ALTO MAIPO PROJECT – CHILE

**REVIEW OF THE TUNNELLING CONDITIONS RELATING TO THE VOLCAN
AND ALFALFAL II TUNNELS**

DB POWELL & ASSOCIATES LTD

APRIL 2017

Figure 3.6 - El Volcan Tunnel Geological Profile, taken from 610-GE-PLA-002, showing the geological structure

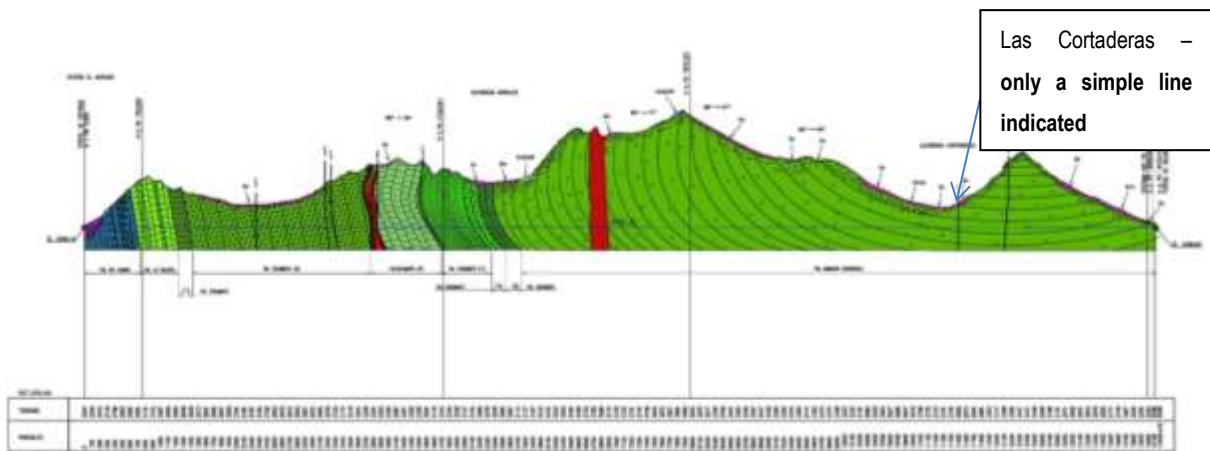
Section AM-C0610 provides no specific information on either of these types of features (Fig.3.6). The update rectifies this to some extent and two major fault systems are now recognized. While this may allow the CNM JV to anticipate approximately where difficult tunneling conditions could occur, there is still a considerable amount of information required to characterize these major faults.

Figure 3.7 - El Volcan Tunnel Geological Profile, taken from 610-GE-PLA-002, with the geological Formations.

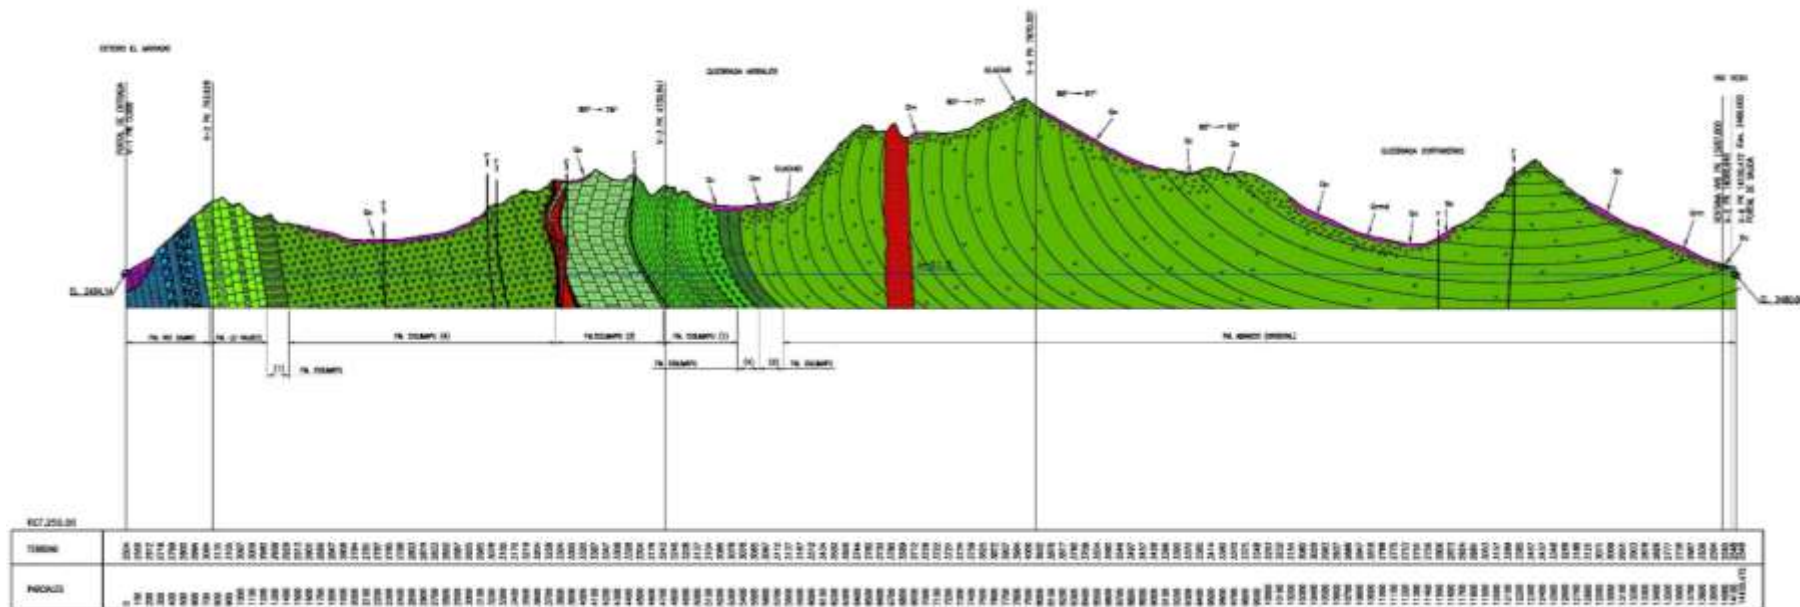
Table 3.6 is simply a brief description of what is presented on the generalized tunnel cross-section – Figure 3.7.

Figure 3.8 - Alfalfal II Tunnel Geological Profile, taken from 620-GE-PLA-002.

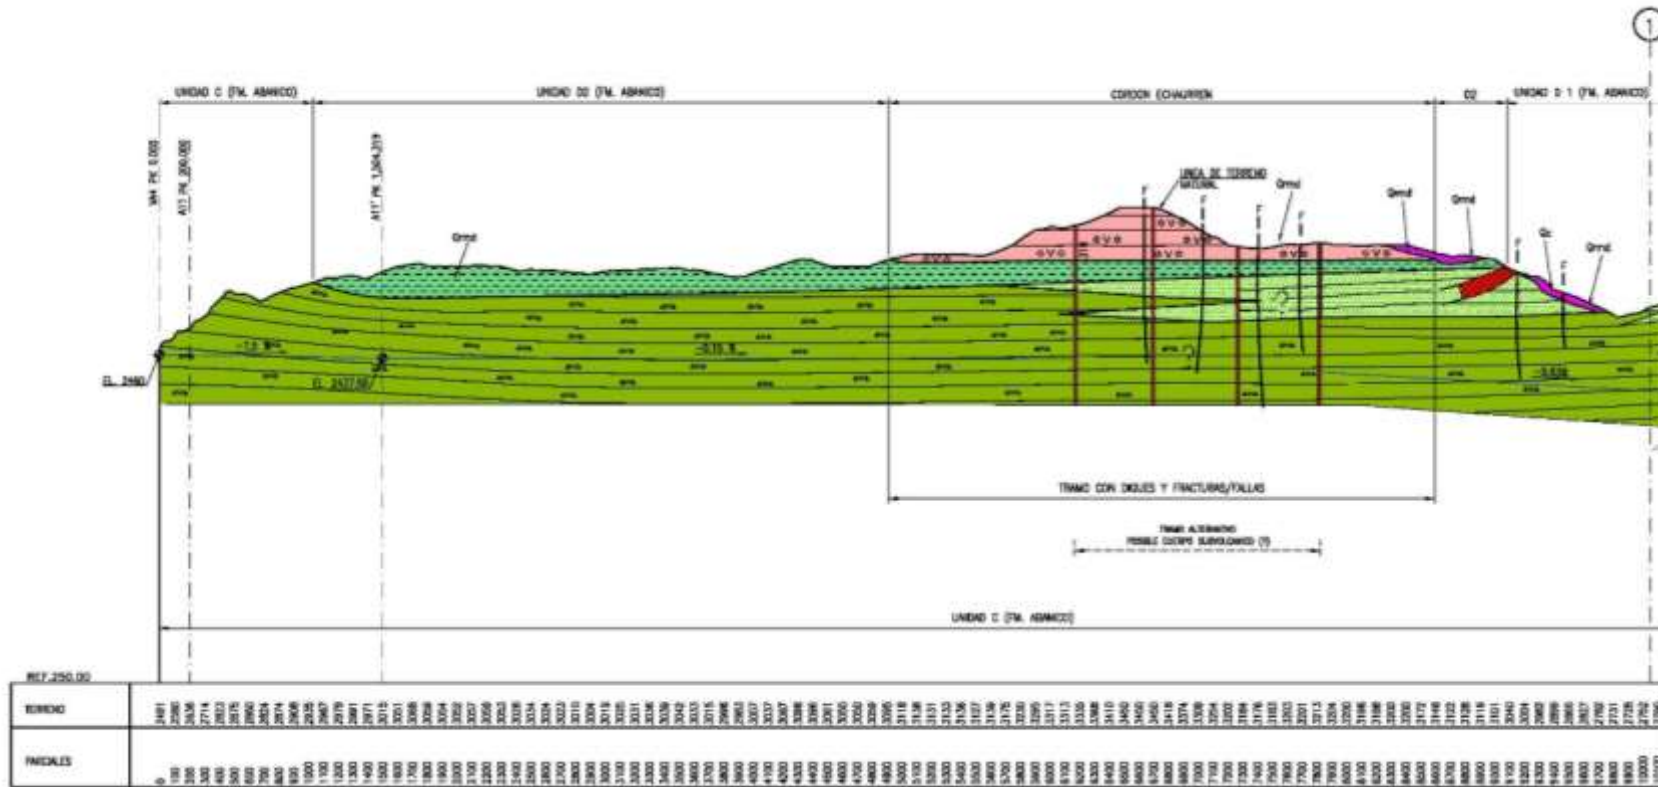
Section 3.3.2 discusses the sub-surface geology and geotechnics. It provides the following information on the section from VA4 portal to 12 km. The distribution of the units within the Formation is shown in Figure 3.8.

Figure 4.7 - Profile at chainage 13+120.8 showing extent of collapse (green zone)

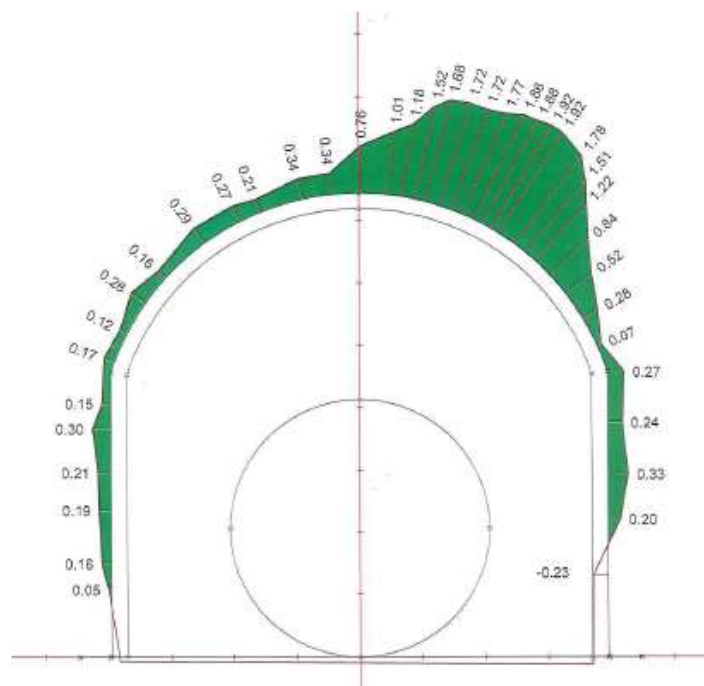
Due to the Very Poor ground conditions (Class V) which continued to chainage 13+188 the decision was taken to remove the TBM and relocate it to the Alfalfal II tunnel. A second TBM has been procured and it is intended to continue driving the Volcan Tunnel from V5 with a refurbished Robbins open face hard rock TBM, i.e. similar to the TBM being moved to the Alfalfal II Tunnel. A launch chamber and extension of the tunnel is currently being constructed for this purpose.
